Access Compliance Report

Public Rights-of-Way

Main Street: BALL_RD Cross Street: S_BROOKHURST_ST Location: SW

ADA ID: SGAT220202154208 Signal Type: One Push Button-Non APS Overall Compliance: No Severity Scores: BTN 1: 10 BTN 2: N/A No BTN: N/A

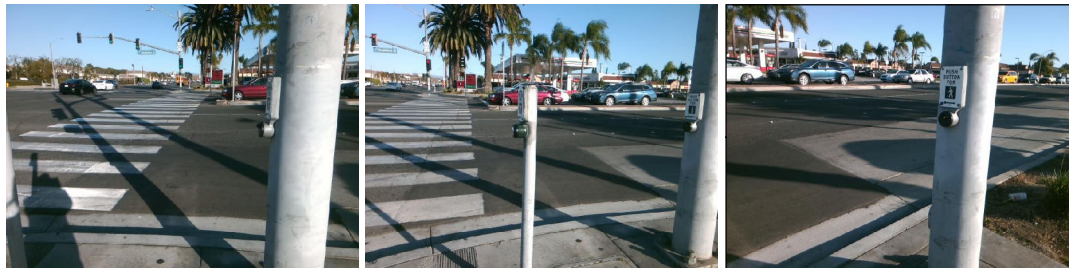
N/A Is Button 1 APS or Non-APS?	NonAPS	N/A Is Button 2 APS or Non-APS?	N/A
N/A B 1 VibroTact Arrow?	N/A	N/A B 2 VibroTact Arrow?	N/A
N/A B 1 VibroTact Parallel to Xing?	N/A	N/A B 2 VibroTact Parallel to Xing?	N/A
N/A B 1 VibroTact Contrast	N/A	N/A B 2 VibroTact Contrast	N/A
No B 1 Pilot Light?	No	N/A B 2 Pilot Light?	N/A
N/A B 1 Pilot Light Illumination?	N/A	N/A B 2 Pilot Light Illumination?	N/A
N/A B 1 Walk Indicator Type	N/A	N/A B 2 Walk Indicator Type	N/A
N/A B 1 Walk Indicator Audible?	N/A	N/A B 2 Walk Indicator Audible?	N/A
N/A B 1 Locator Tone?	N/A	N/A B 2 Locator Tone?	N/A
N/A B 1 Tone Audible Range?	N/A	N/A B 2 Tone Audible Range?	N/A
B 1 Addl APS Features?	No	B 2 Addl APS Features?	N/A
B 1 Addl APS Features Notes	N/A	B 2 Addl APS Features Notes	N/A

N/A B 1 FWD Approach Obstruction?	N/A	N/A	B 2 FWD Approach Obstruction?	N/A	
N/A B 1 FWD Approach Obstruction Dist (in)	N/A	N/A	B 2 FWD Approach ObstructionDist (in)	N/A	
N/A B 1 PARA Approach?	N/A	N/A	B 2 PARA Approach?	N/A	
N/A B 1 PARA Approach Constrained?	No	N/A	B 2 PARA Approach Constrained?	N/A	
Yes B 1 PARA Approach Reach (in)	3	N/A	B 2 PARA Approach Reach (in)	N/A	
N/A B 1 PARA Approach Width (in)	N/A	N/A	B 2 PARA Approach Width (in)	N/A	
N/A B 1 PARA Approach Obstruction?	No	N/A	B 2 PARA Approach Obstruction?	N/A	
N/A B 1 PARA Approach Obstruction Dist (in)	N/A	N/A	B 2 PARA Approach Obstruction Dist (in)	N/A	
Yes B 1 Clear Floor Space Slope (%)	0.6	N/A	B 2 Clear Floor Space Slope (%)	N/A	
Yes B 1 Clear Floor Space XSlope (%)	0.4	N/A	B 2 Clear Floor Space XSlope (%)	N/A	
N/A B 1 PAR Slope (%)	2.6	N/A	B 2 PAR Slope (%)	N/A	
Yes B 1 Height (in)	45	N/A	B 2 Height (in)	N/A	
No B 1 Pressure (#)	7	N/A	B 2 Pressure (#)	N/A

No B 1 Closed Fist Operation?	No	N/A	B 2 Closed Fist Operation?	N/A	
No B 1 Diameter (in)	0.25	N/A	B 2 Diameter (in)	N/A	
N/A B 1 Crossing Direction	SE	N/A	B 2 Crossing Direction	N/A	
Yes B 1 DistanceTo XWalk (in)	60	N/A	B 2 DistanceTo XWalk (in)	N/A	
Yes B 1 DistanceTo Curb (in)	23	N/A	B 2 DistanceTo Curb (in)	N/A	
Parcel Identification Number	127-371-65				
Google Street View Link					
http://www.google.com/maps/@?api=1&map_action=pano&viewpoint=33.81758842,-117.95910542

Possible Solutions: Replace Signal Push Button With APS Button.
